MEMORANDUM

RE: New Richmond – Federal Foam; warehouse expansion

The City has received plans for construction of a 100,650 square foot warehouse building within the New Richmond Business and Technical Park. The proposed building is an expansion of Federal Foam's existing facility located southwest of Cernohous Avenue and Wisconsin Drive and will be connected to the existing building by an enclosed breezeway. The proposed development requires site plan review in accordance with Section 121-30 of the Zoning Ordinance that is subject to review and approval of the Development Review Committee. Federal Foam has also applied for a conditional use permit to allow for exterior materials other than that required by the Zoning Ordinance for buildings within the Z7 District in accordance with Section 121-32 of the Zoning Ordinance that is subject to approval by the Plan Commission. A public hearing to consider the conditional use permit application has been noticed for the Plan Commission meeting on 8 May 2018, which was continued to the Plan Commission meeting on 15 May 2018 to allow the developer to submit revised plans.

**NEW WAREHOUSE ADDITION FOR:
FEDERAL FOAM TECHNOLOGIES, INC.
600 WI

C500 - GRADING PLAN

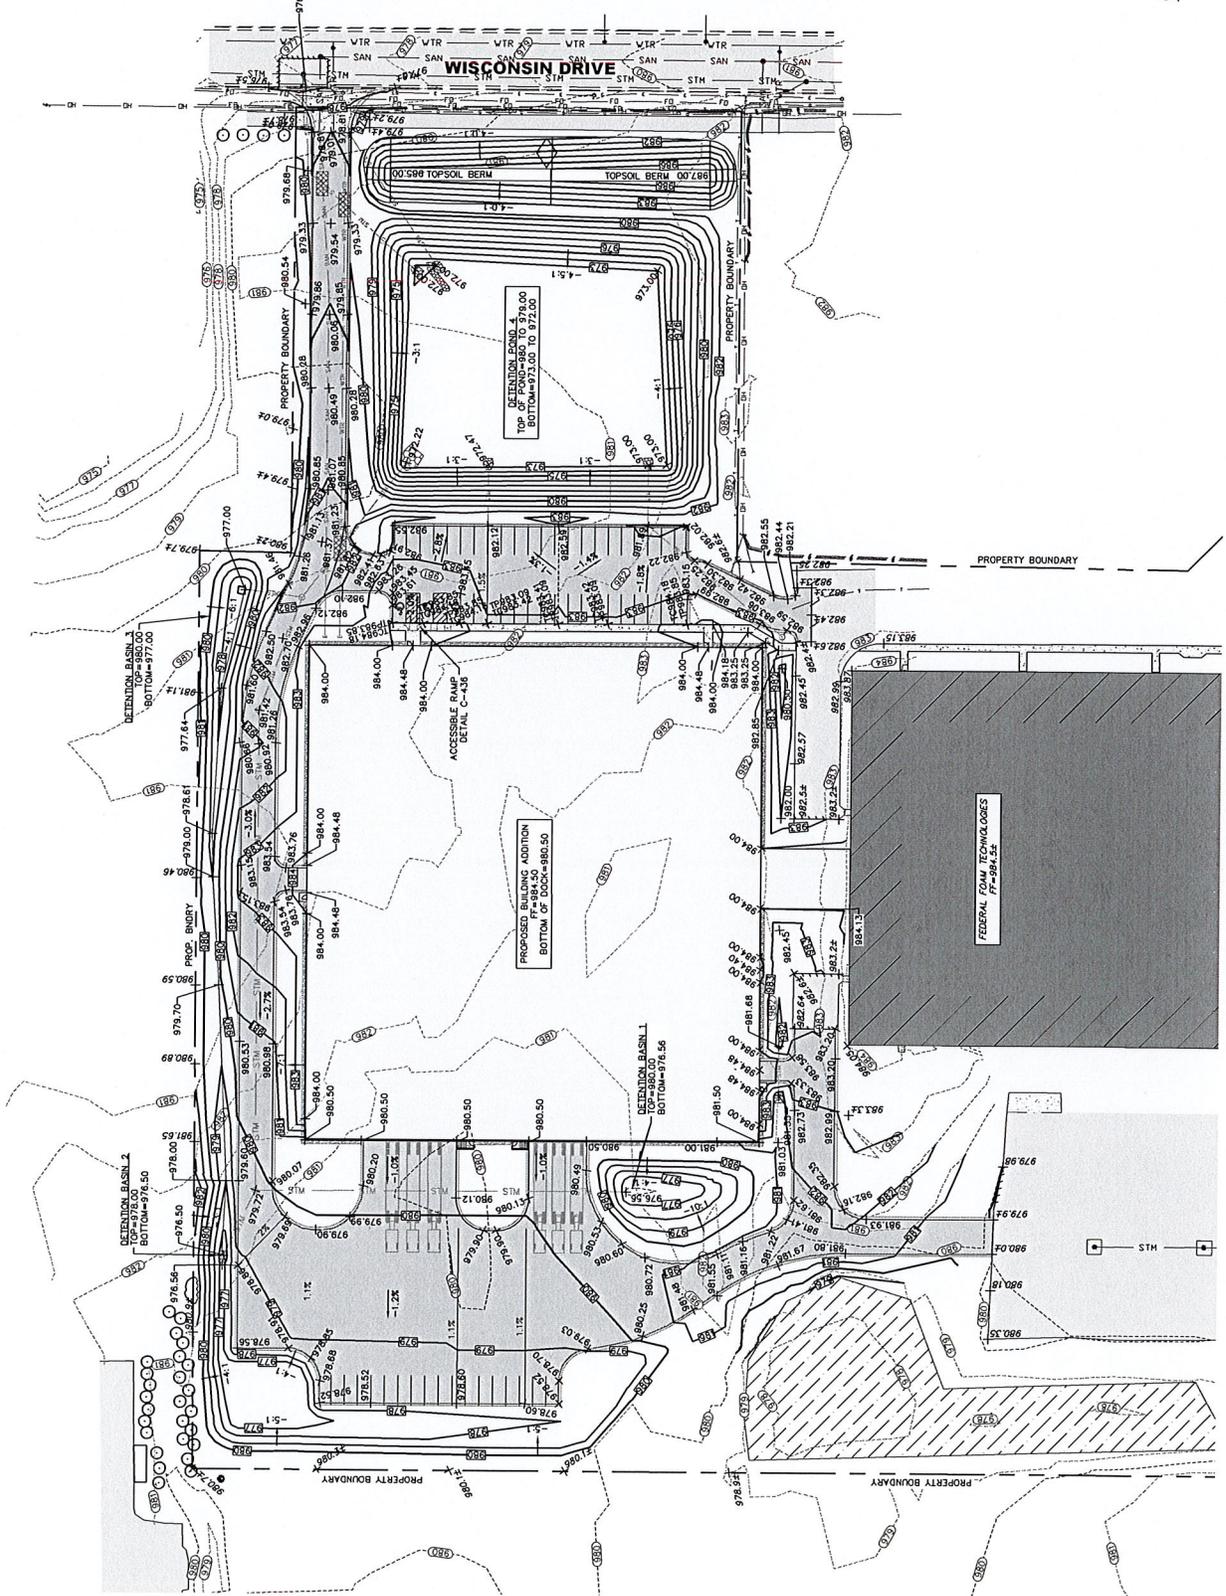
Grading. The developer has submitted a grading plan and erosion control plan for the proposed site plan. All grading, drainage and utility issues are subject to review and approval of the Public Works Director.

5. All grading, drainage, and erosion control shall be subject to review and approval of the Public Works Director, including execution of a maintenance agreement.

Existing Land Use should be changed to

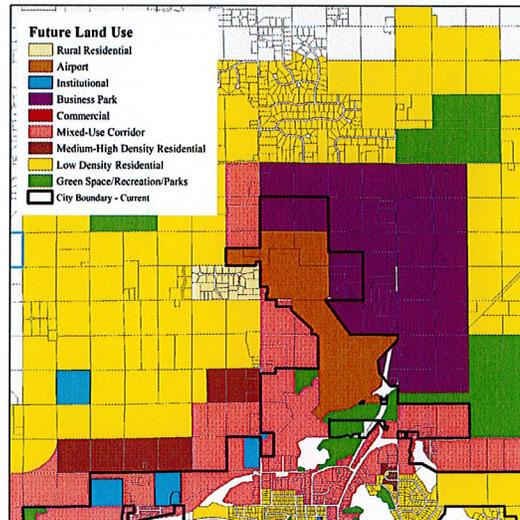
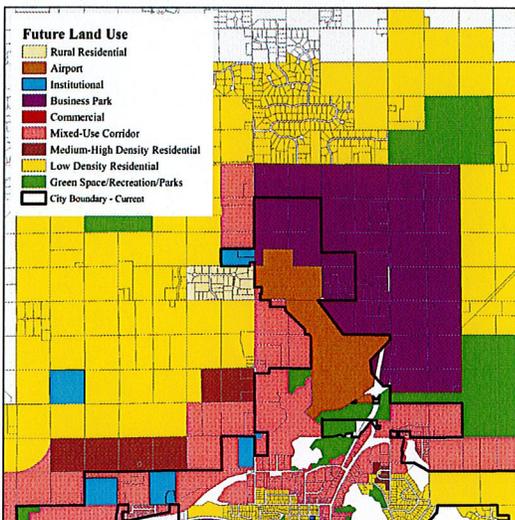
On both the existing and future land use maps the airport property needs to be updated and put in brown versus institutional.
